World Forum for Harmonization of Vehicle Regulations

Proposal for a Supplement 5 to the 04 series of amendments to UN Regulation No. 79 (Steering equipment)

Submitted by the Working Party on Automated/Autonomous and Connected Vehicles*

Model A

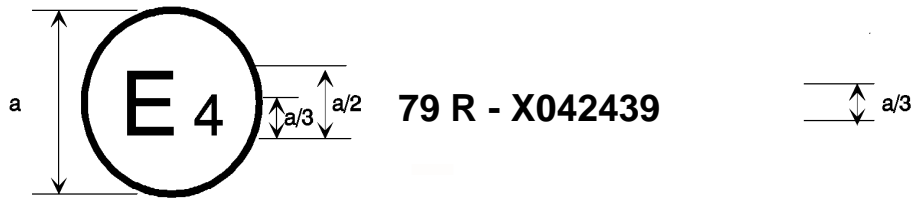
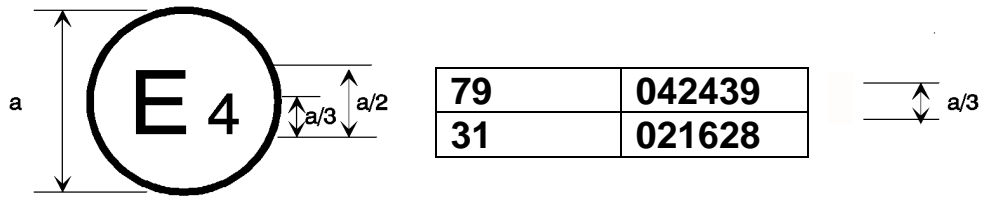
Annex 2, amend to read with square brackets amended as appropriate :

The above approval mark affixed to a vehicle shows that the vehicle type concerned has, with regard to steering equipment, been approved in the Netherlands (E 4) pursuant to UN Regulation No. 79 under approval No. 042439. The letter “X” preceding the approval number indicates that the vehicle is equipped with ACSF which has been exempted from the requirements of this UN Regulation, and/or that the vehicle is equipped with a steering system which exhibits functionality defined as an ACSF of Category D. The approval number indicates that the approval was granted in accordance with the requirements of UN Regulation No. 79 incorporating the 04 series of amendments.”

Model B
(See paragraph 4.5. of this Regulation)

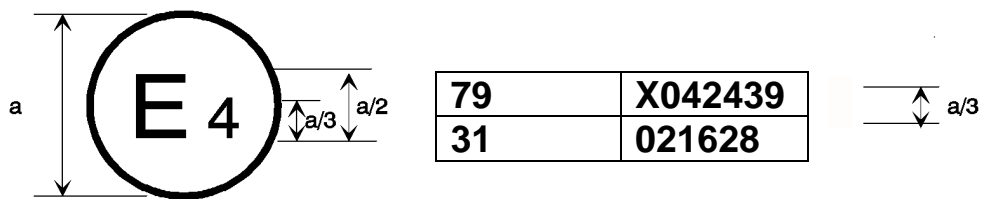
The above approval mark affixed to a vehicle shows that the vehicle type concerned has been approved in the Netherlands (E 4) pursuant to UN Regulations Nos. 79 and 31.⁴ The letter “X” preceding the approval number pursuant to UN Regulation No. 79 indicates that the vehicle is equipped with ACSF which have been exempted from the requirements of this UN Regulation, or that the vehicle is equipped with a steering system which exhibits functionality defined as an ACSF of Category D. The approval numbers indicate that, at the
